# Product Change Notification

## 110880 - 00

<b>Change Notification #:</b>	<b>110880 - 00</b>
<b>Change Title:</b>	<b>Intel Ethernet Server Adapters X520-SR1/X520-SR2 (Spring Fountain SR1/SR2 OEM generic/Retail), and Intel Ethernet Server Adapters X520-LR1/X520-DA2 (Spring Fountain LR1/DA2 Retail)  PCN 110880-00  Label  Updating KCC (Korean Communications Commission) logo to the new KC logo on PB (printed board) and all box labels</b>
<b>Date of Publication:</b>	<b>July 26, 2011</b>

**New KC logo, Date of Manufacture, Product Identification number, Made in COO** (Picture 4, all of the information showing in Picture 4 is for example only and may not reflect actual data)

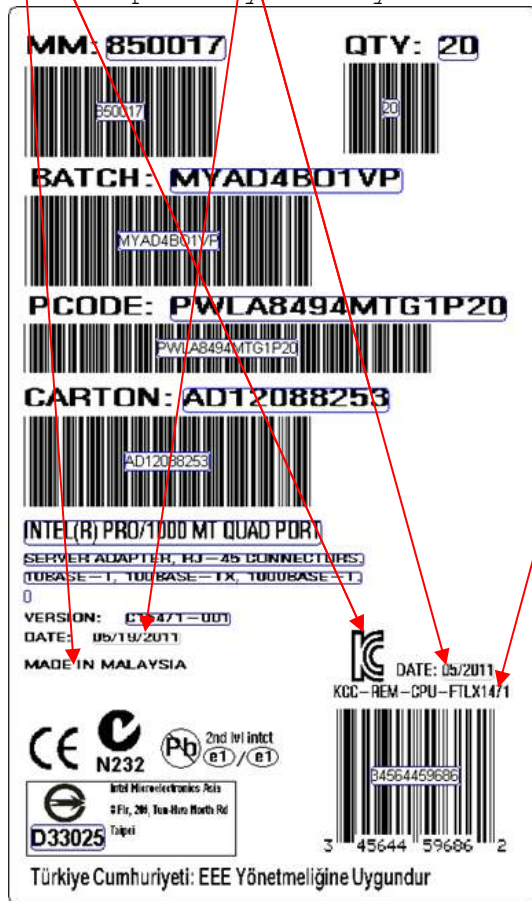
To comply with new regulations from Korea, Intel will be adding the new KC logo to the Printed Board (PB) as a label. The label will be added to either the front or the back of the PB depending on space constraints. The new KC logo will also be added to all box labels (product box label and over-pak box label). **(see pictures 1, 3 & 4)**

**Picture 4 showing new KC logo on box label.** The box label already contains the Made in Country of Origin (COO) and the Date of Manufacture, this information will also show on the KC label.
